## 2280 DPU HARDWARE

**WANG****ECO****ECO NO. 36643**

PART NO. 210-7422  
 DWG NO. 7422  
 MODEL NO. 2280  
 CLASS I (II) III

DESCRIPTION  
 2200 SMD ECC/Device Interface  
 PEP # PEP# H0133A  
 TYPE  HARDWARE  SOFTWARE

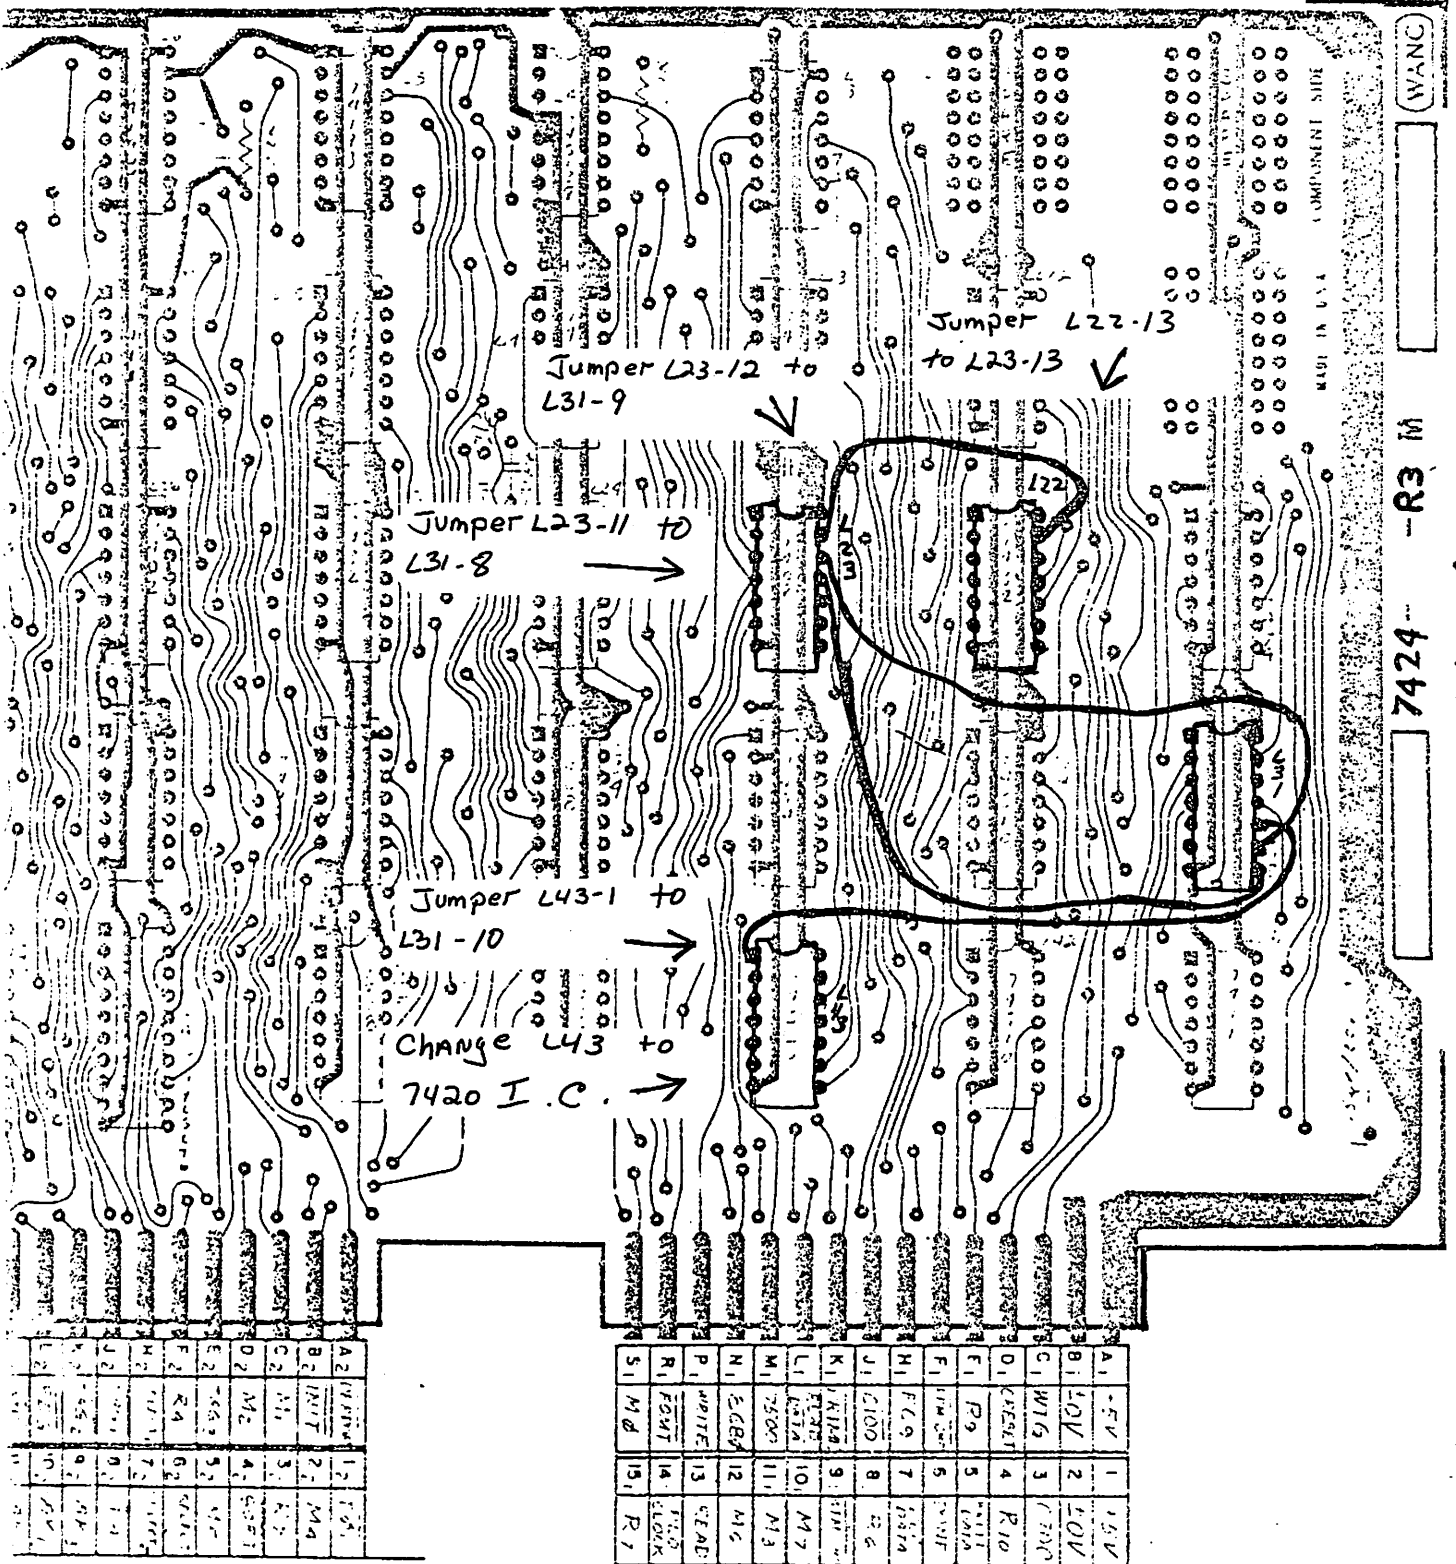
Change L43 to 7420 I.C.

1. CHANGE L43 FROM A 74S20 TO A 7420 ( WL#376-0004 ).
2. JUMPER L31-8 TO L23-11.
3. JUMPER L31-9 TO L23-12.
4. JUMPER L31-10 TO L43-1.
5. JUMPER L23-13 TO L22-13.
6. CUT ETCH AT BASE OF L12-2.

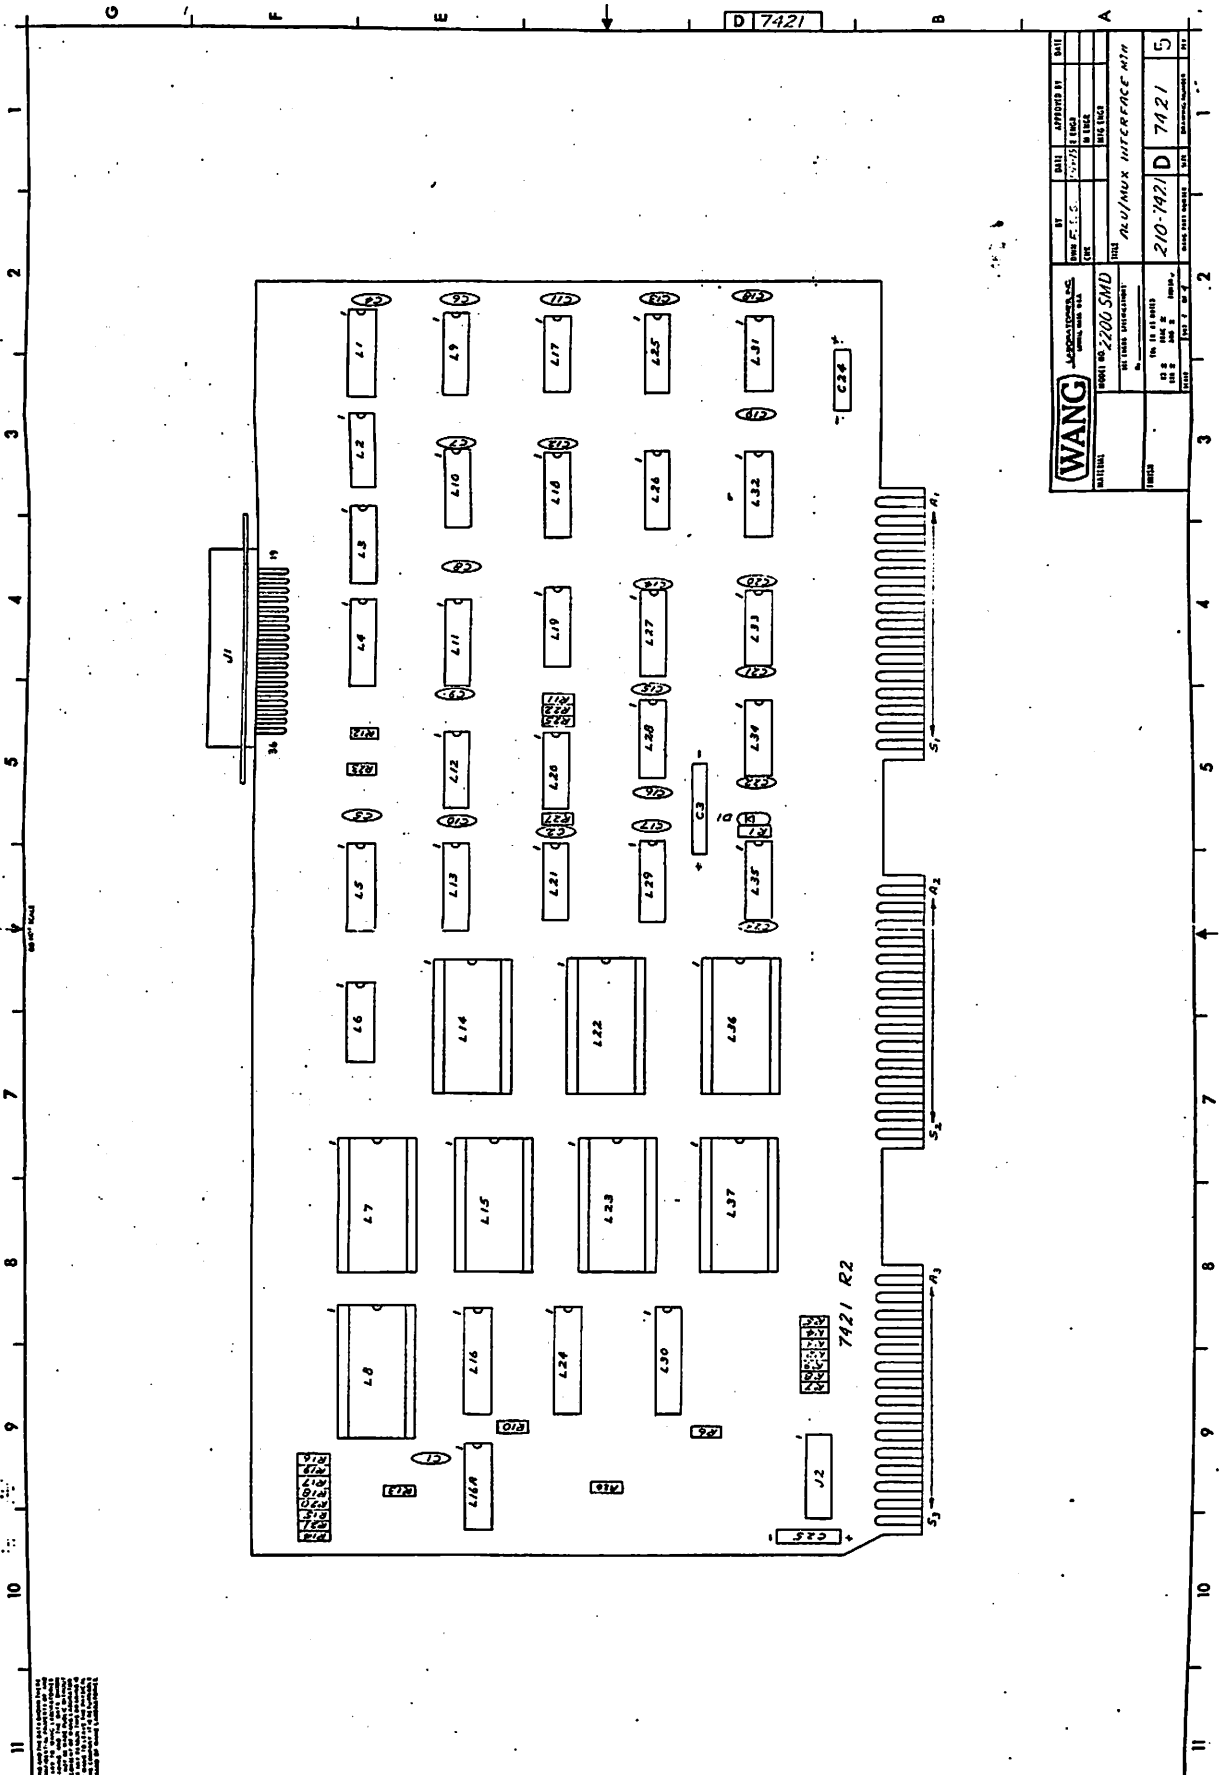
WIRE FROM L38 PIN 2, 3 TO R105 TOP

CUT BTCH BTWN L38 PIN 2 + PIN 19

CUT BTCH BTWN L38 PIN 19 + R105 TOP

FIGURE 2: 210-7422, COMPONENT SIDE  
RESISTOR LOCATIONS

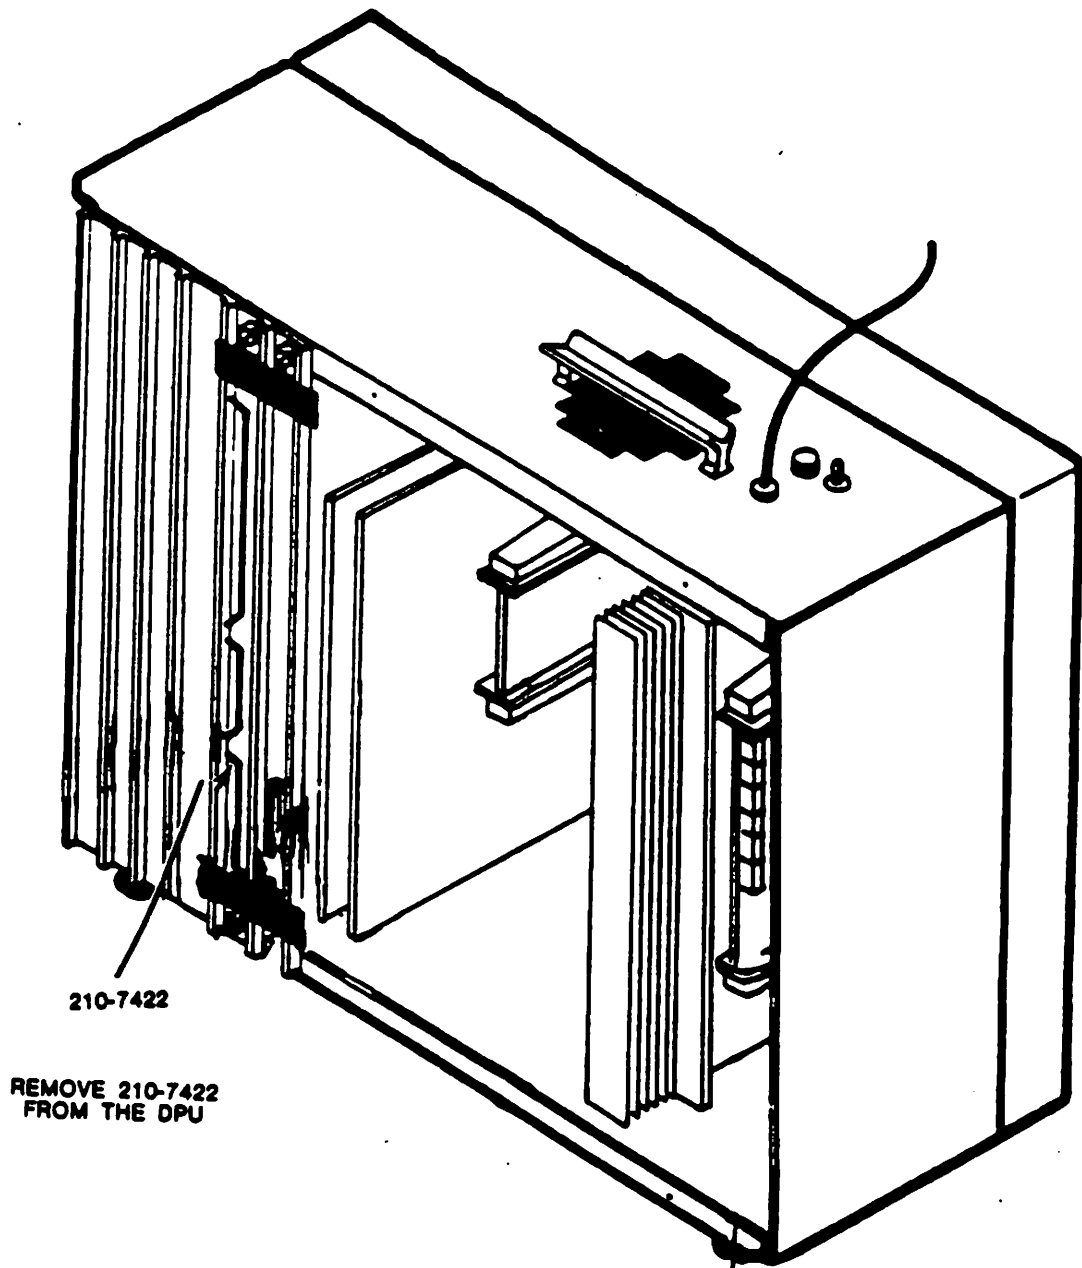
D. Make the following changes to the 210-7422 Artworks R1-R6 board. (Figure 2)
